Informal Document No. 12
(31. GRSP, 13–17 May 2002,
agenda item 2, ISOFIX)

Presented by the Expert from Germany

Conditional Use of Top Tether Anchorage in the ISOFIX Proposals (Reg. 14, 16, 44)

**Measurement of the stiffness of
seating cushions by means
of the SFAD**

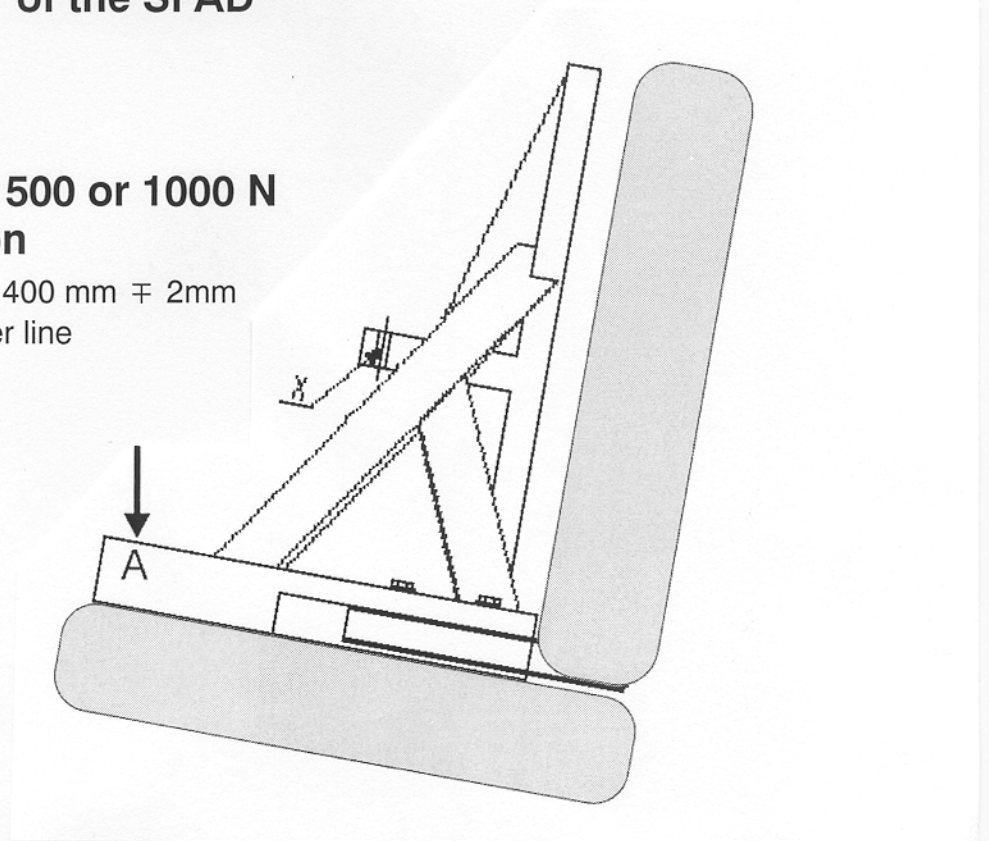
A suitable device for testing seating cushion stiffness is the “static force application device” (SFAD), see [figure 1](#); it is already described in the existing ISOFIX Reg. 14 proposal.

In a German test series the SFAD was used respective to [figure 1](#) in 8 German vehicle types from 3 different manufacturers. The cushion compressions were measured with forces of 500 N and mostly 1000 N. The same was done on the Reg. 44 test bench and the compressions were compared, [figure 2](#). The test bench cushion proved to be softer than the 8 vehicle seating cushions. Additionally the test bench seating cushion is much thicker than the vehicle seating cushions.

Conclusion: We propose the test of [figure 1](#) with 500 N at the vehicle seating cushion with the requirement that a compression of less than 55 mm (taken from the test bench) shall allow to resign from a top tether anchorage. An ISOFIX test on the test bench would then be conservative in respect to the performance of the CRS in the vehicle.
